MONTICELLO NUCLEAR GENERATING PLANT  
Docket No. 263 License No. DPR-22

Redundant Reactor Building Crane

Responses to Request for  
Additional Information

Changes and Corrections to Design  
Report for Redundant Reactor Building Crane

FIGURE 1

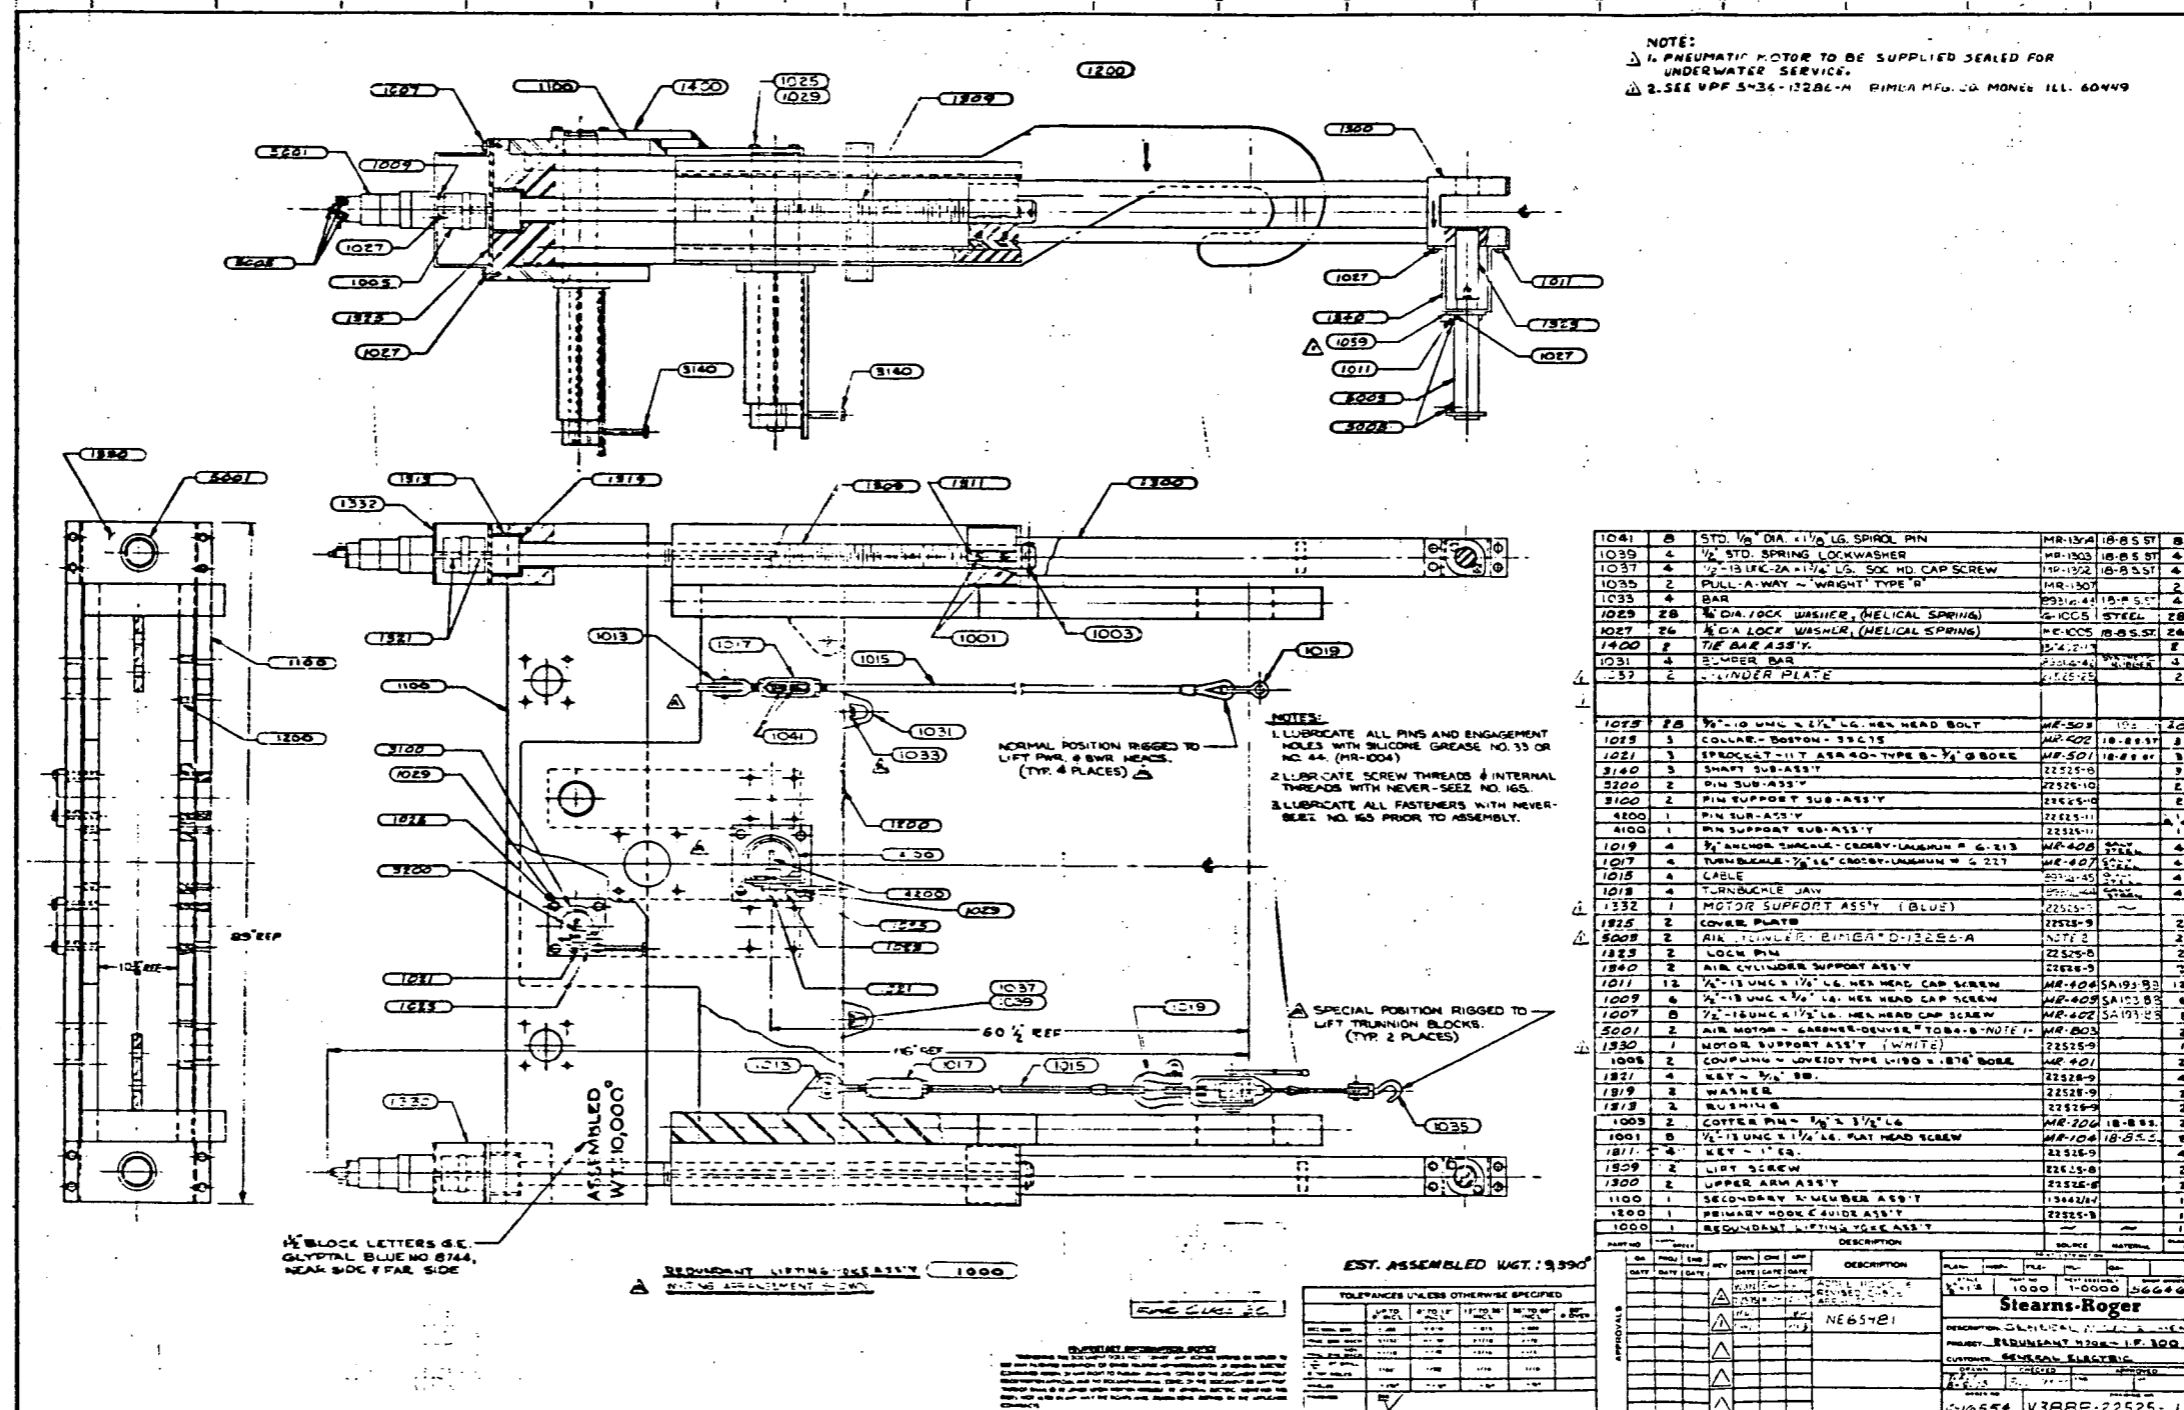
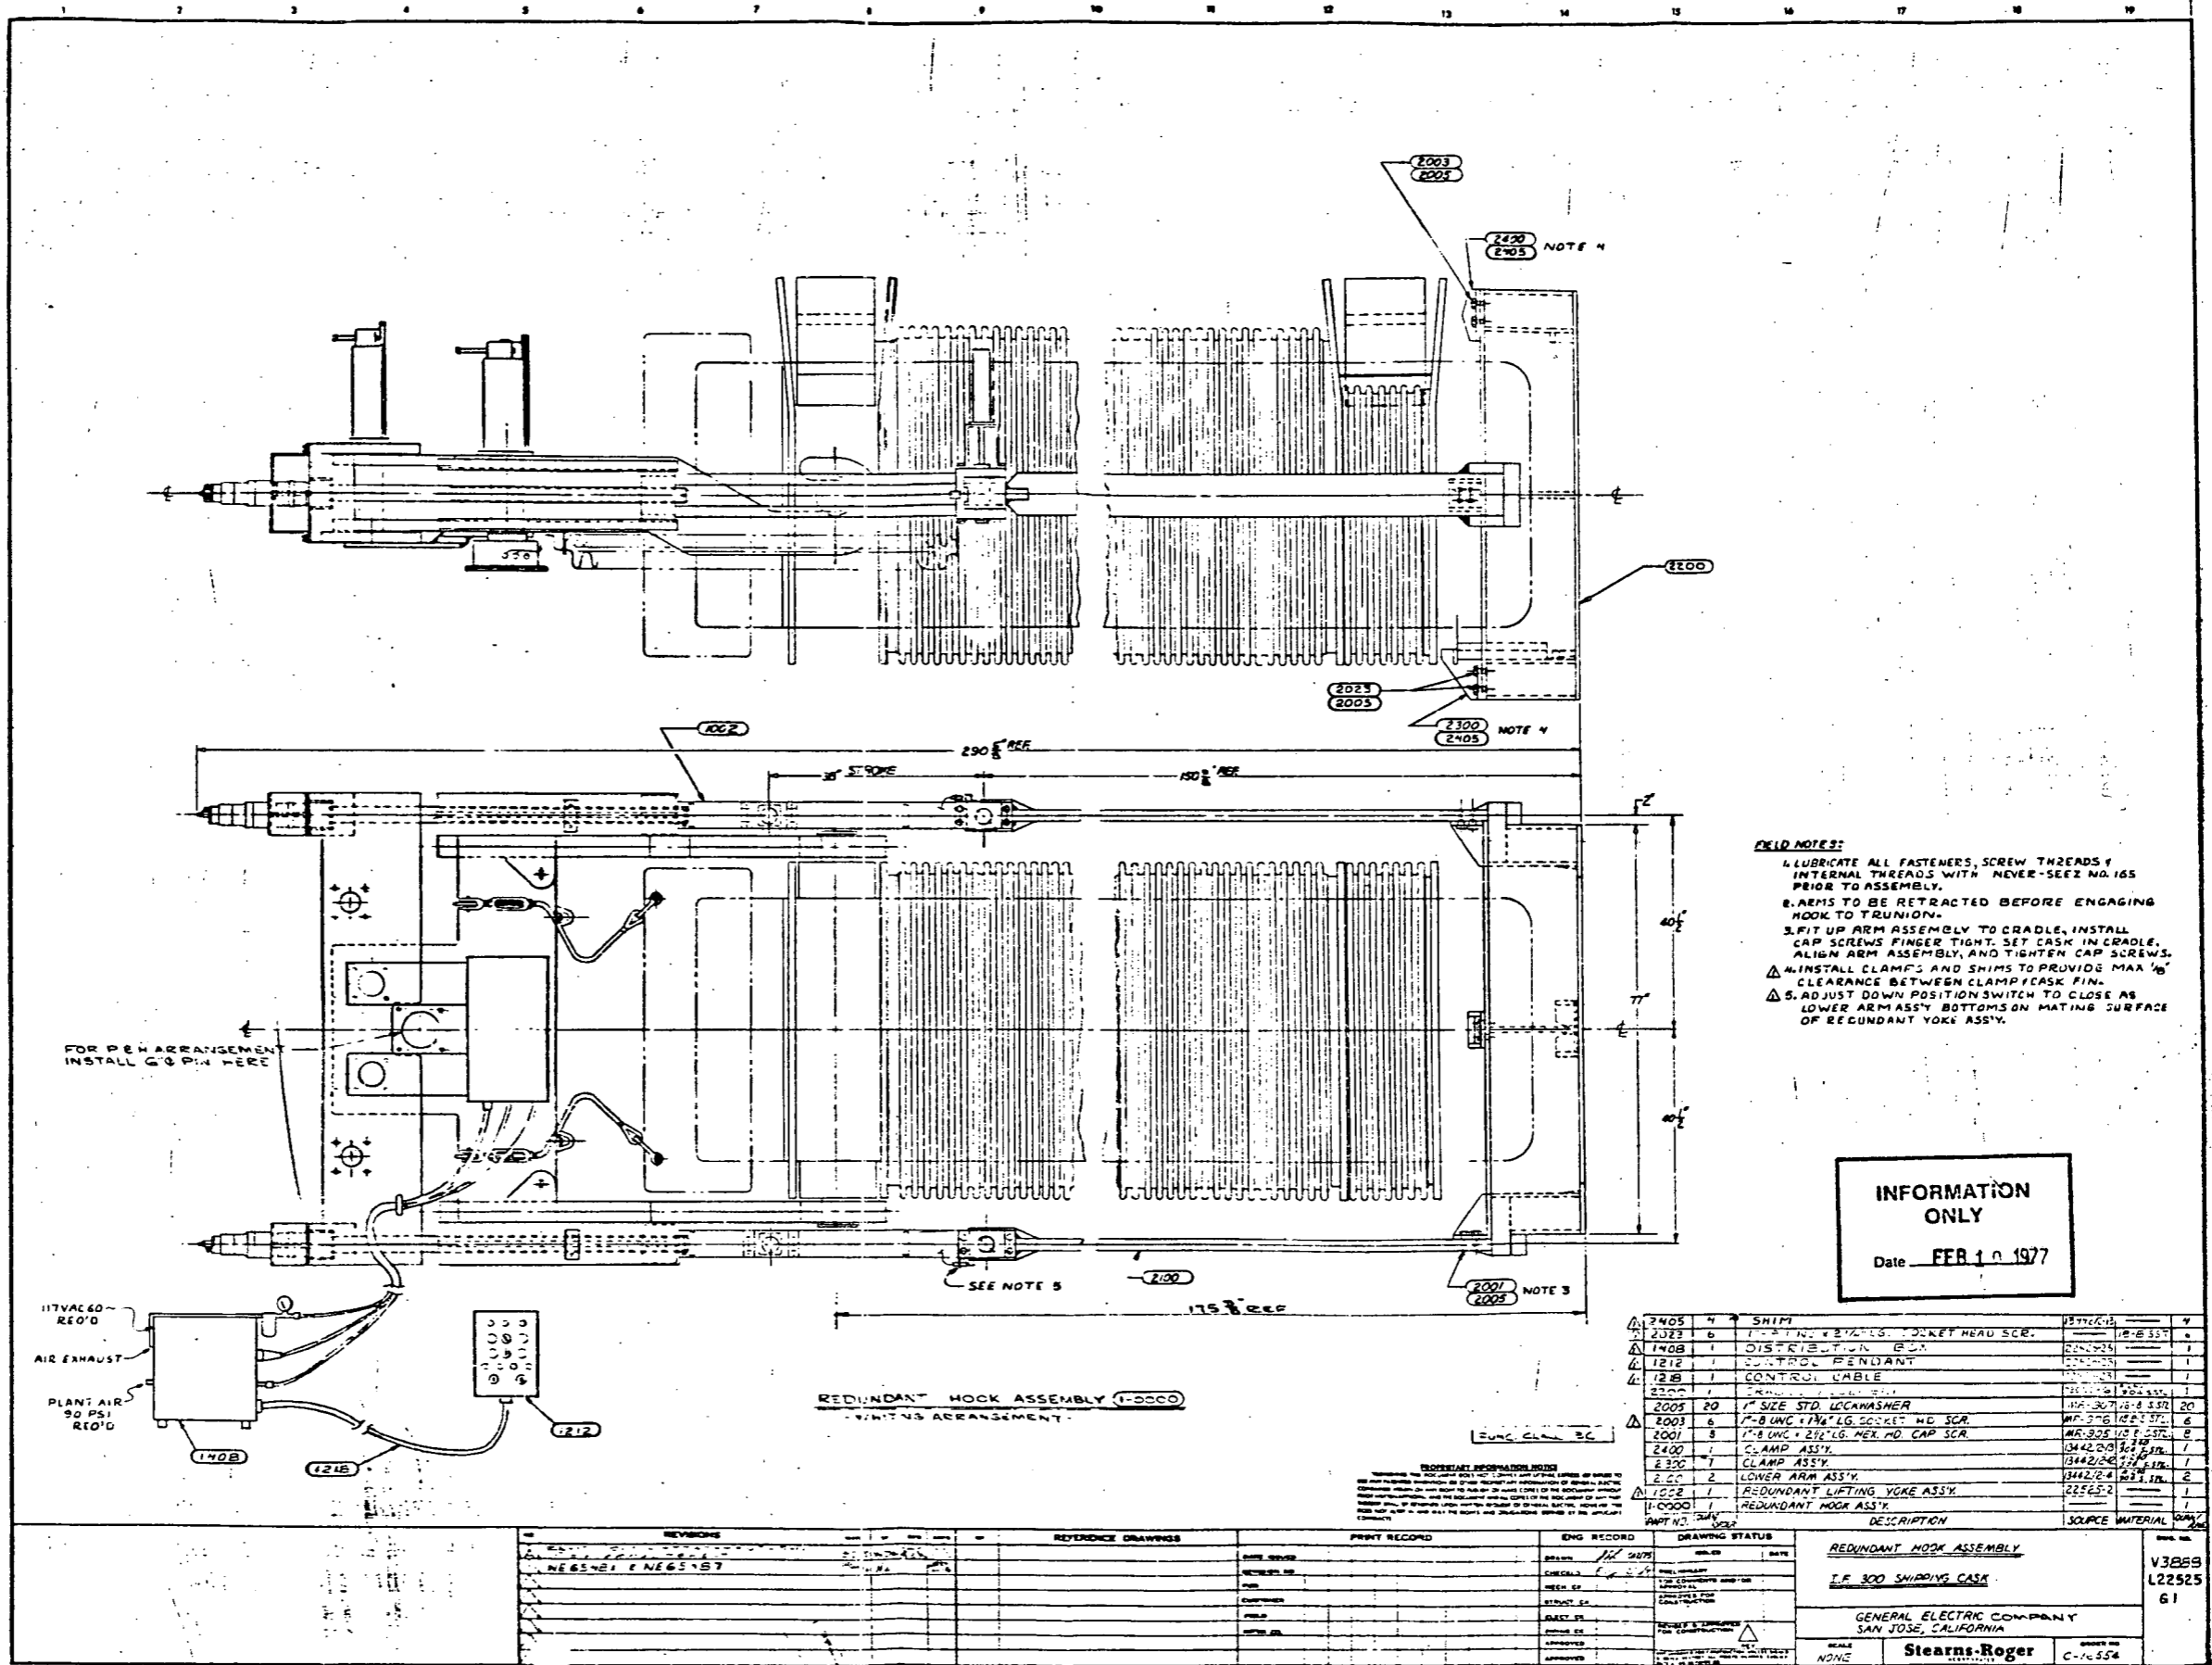
QUESTION 8: Indicate which of the two IF-300 shipping cask handling yokes will be utilized in the Monticello Nuclear Generating Plant. Discuss and compare the relative merits and disadvantages of the two handling yokes as their requirements relate to the limitations at your facility.

RESPONSE 8: Northern States Power Company will use the "redundant IF-300 cask yoke". The non-redundant yoke will not be used. Drawings of the redundant yoke are shown in Figures 1 and 2.
